# DUTCH BROS. COFFEE - CO0907, COLORADO SPRINGS, CO

## SITE DEVELOPMENT PLAN

Title:  
**SITE AND PARKING LOT PLAN**  
5810 OMAHA BLVD  
COLORADO SPRINGS, CO 80915

**Title:**  
LANDSCAPE PLANTING PLAN  
5810 OMAHA BLVD  
COLORADO SPRINGS, CO 80915

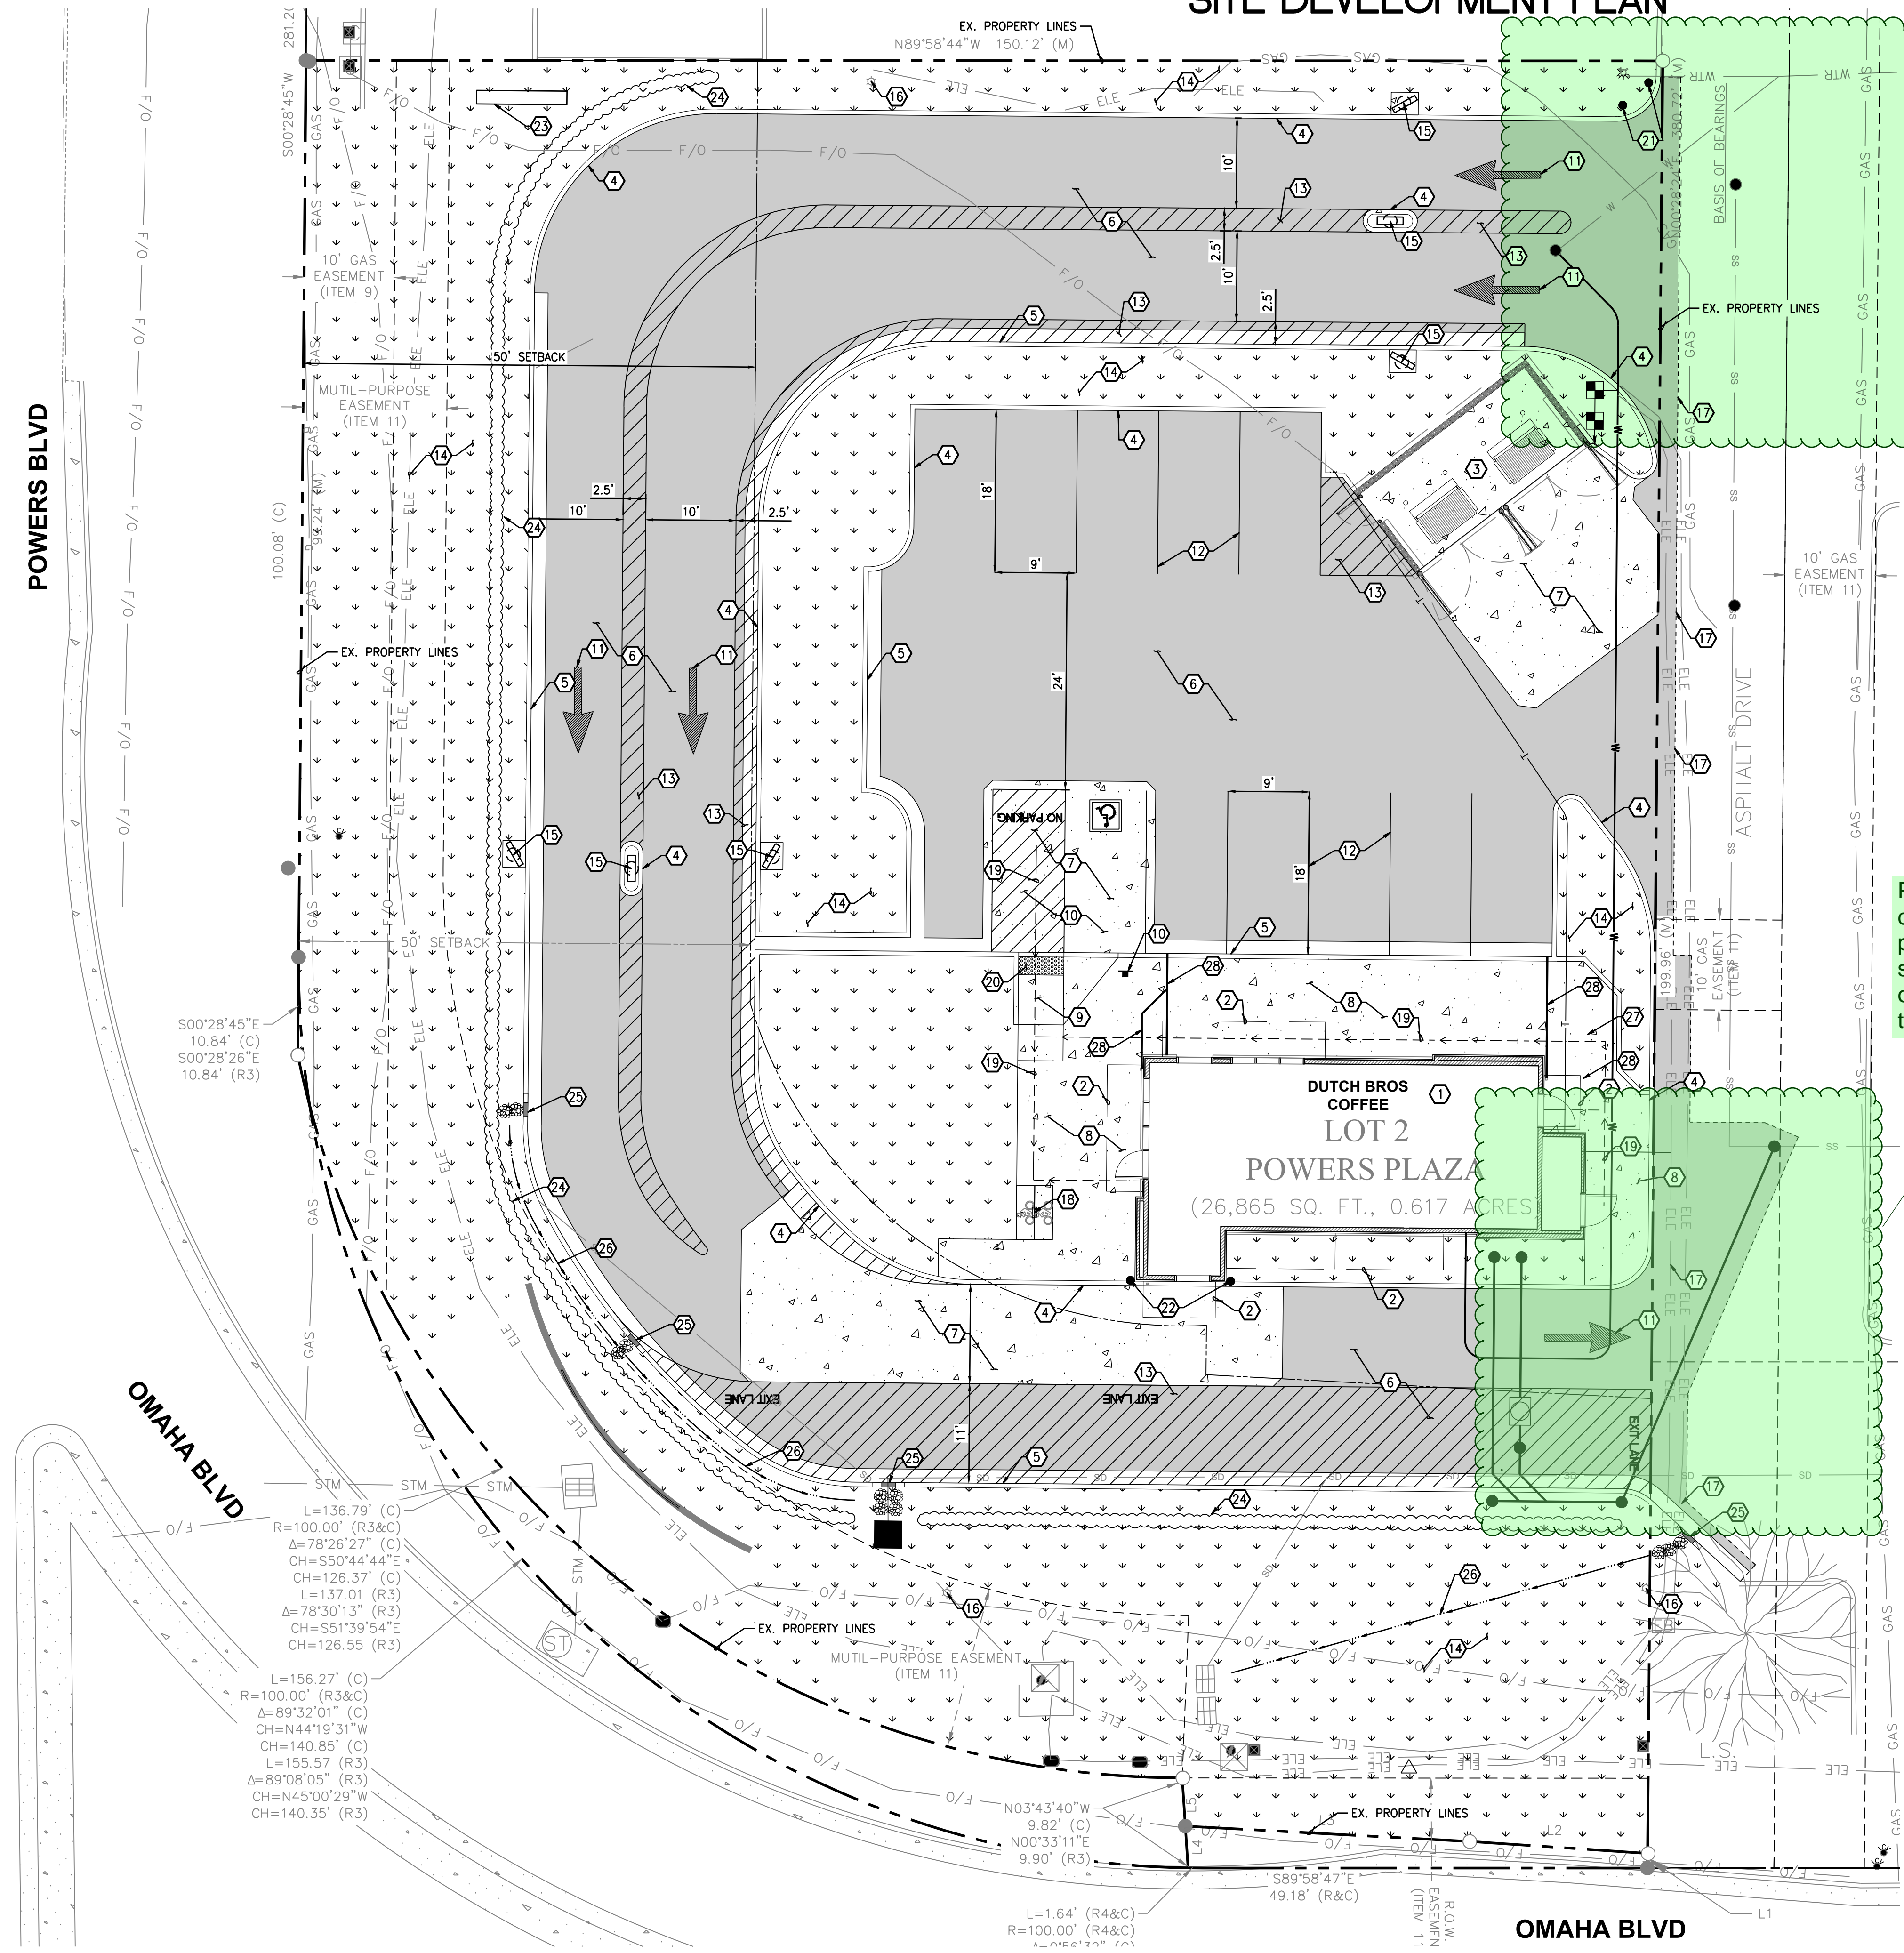
Please include sight distance triangles and any plantings, signs, walls, structures, or other visual obstructions within the triangles where applicable.

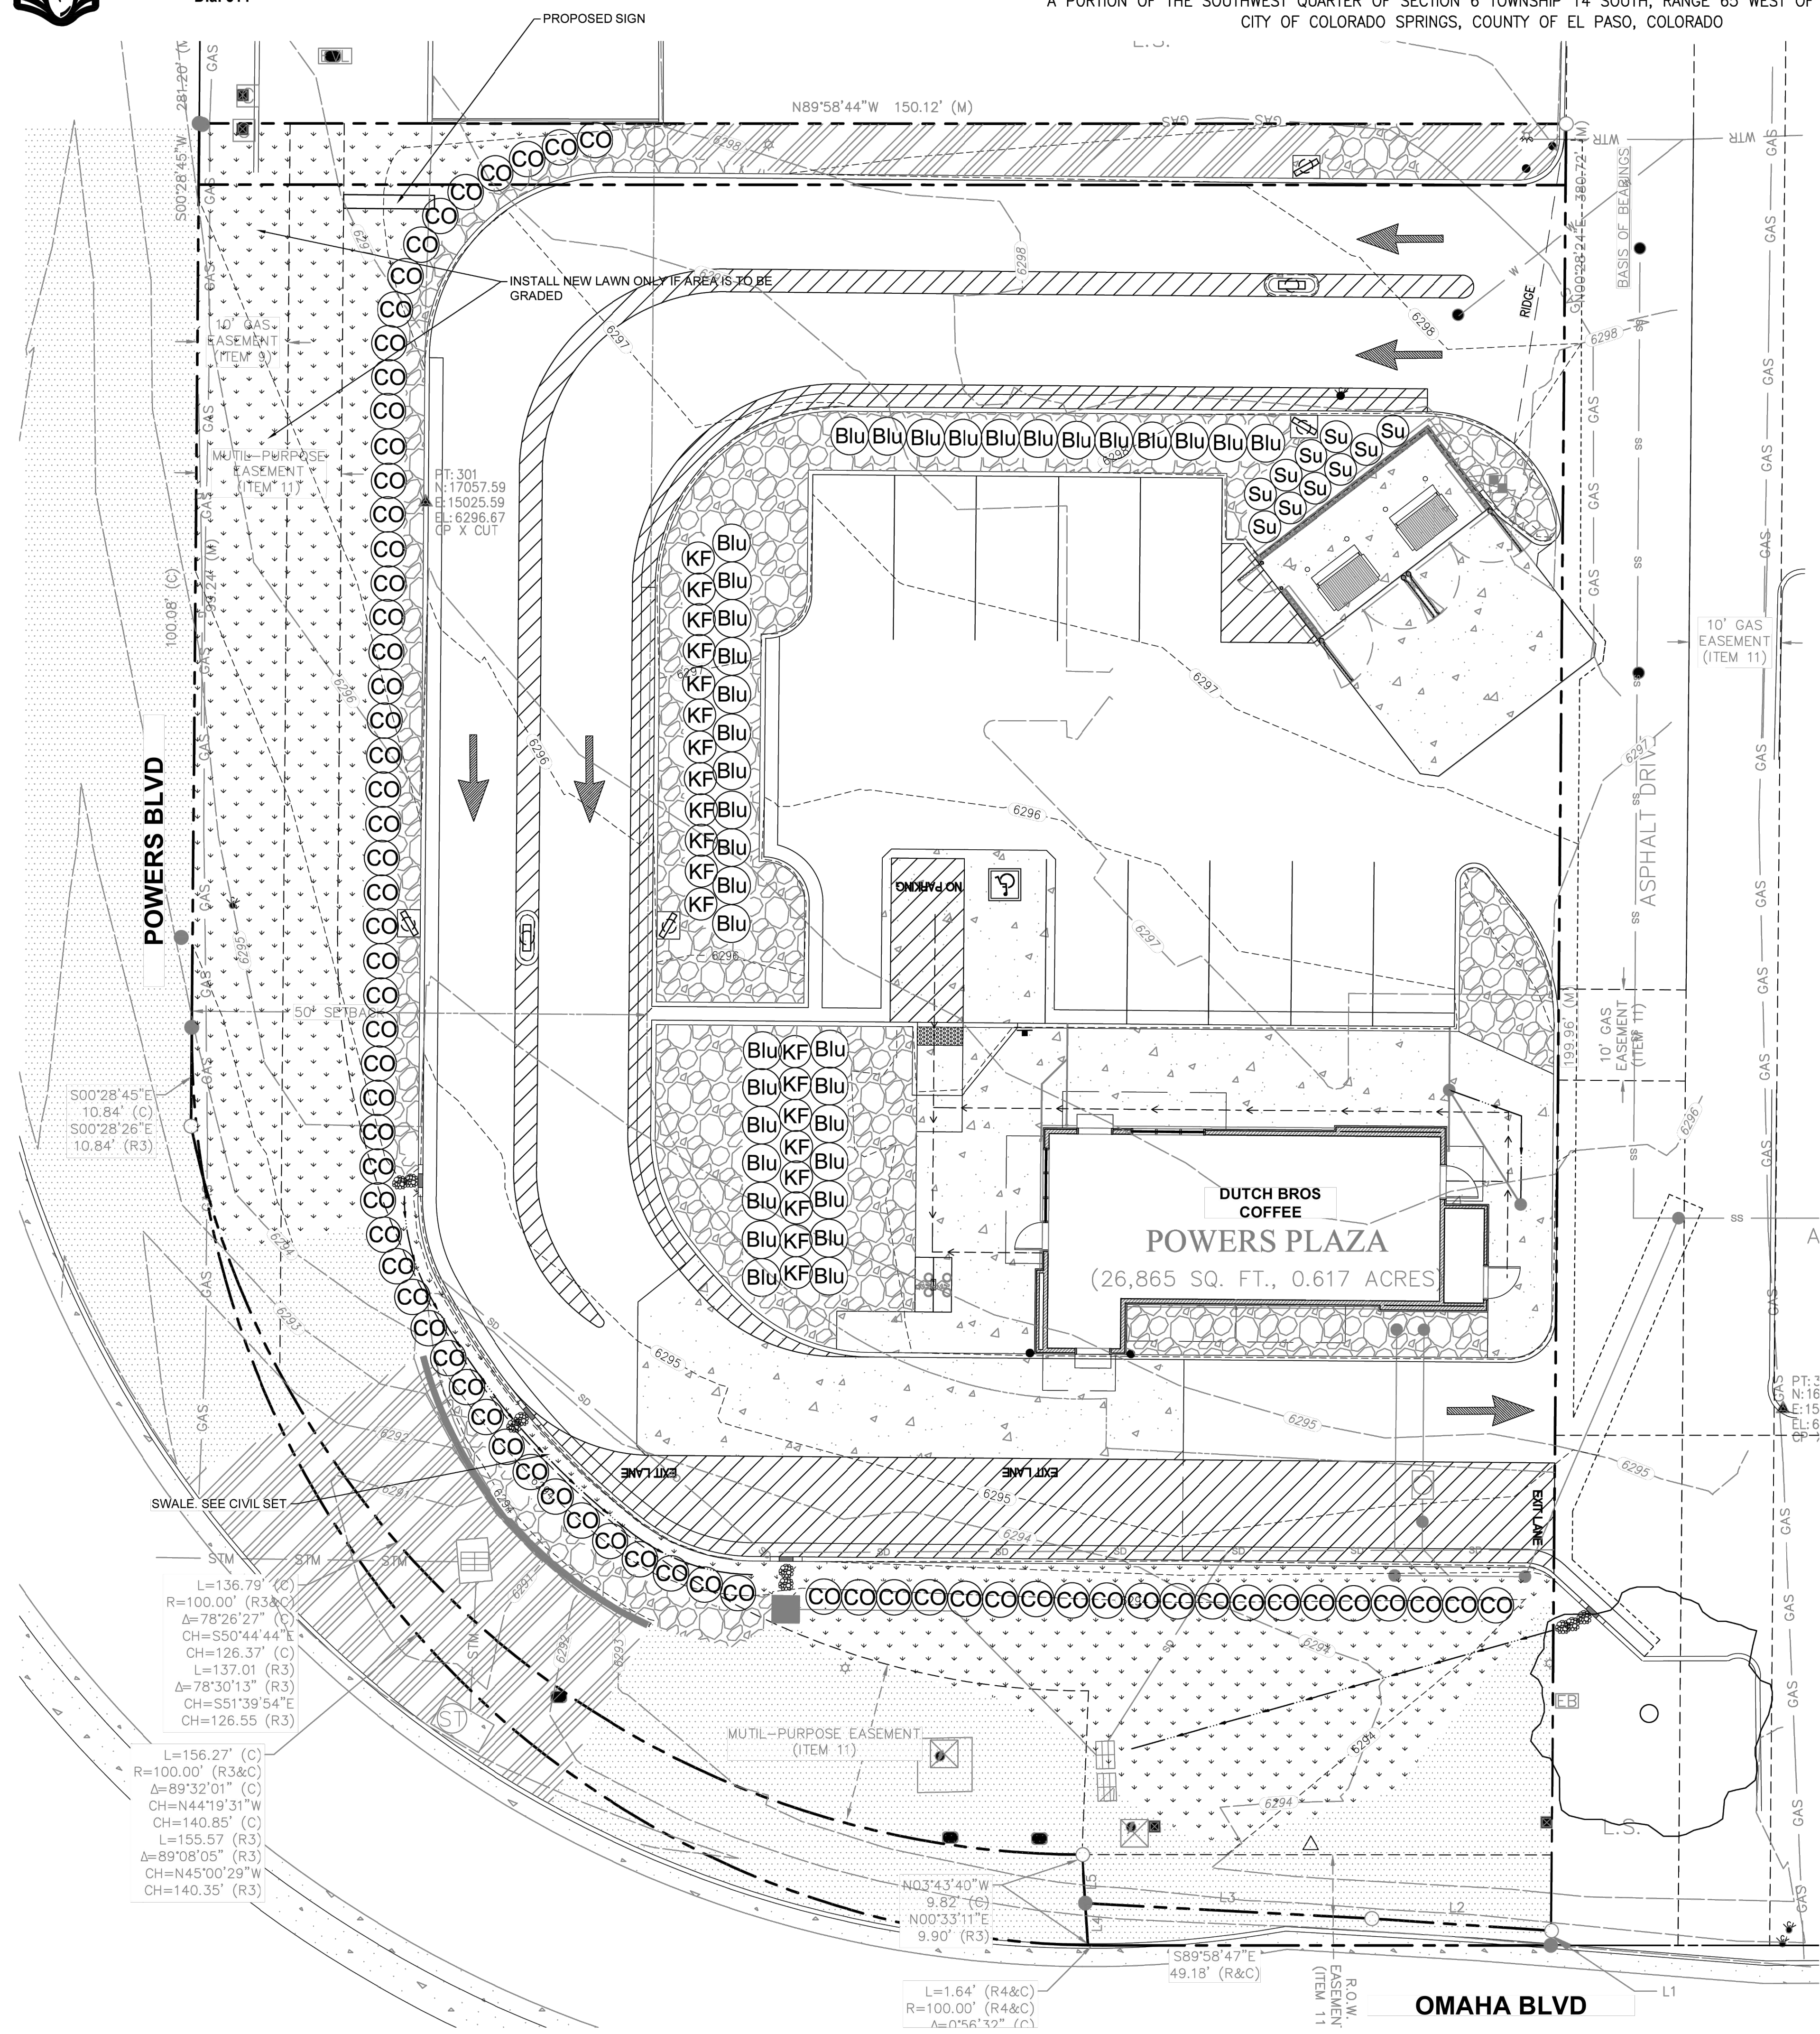
Only 10 spaces are shown on the site plan. Please make this match what is shown.

Please include within this table the required vs provided number count for landscaping items
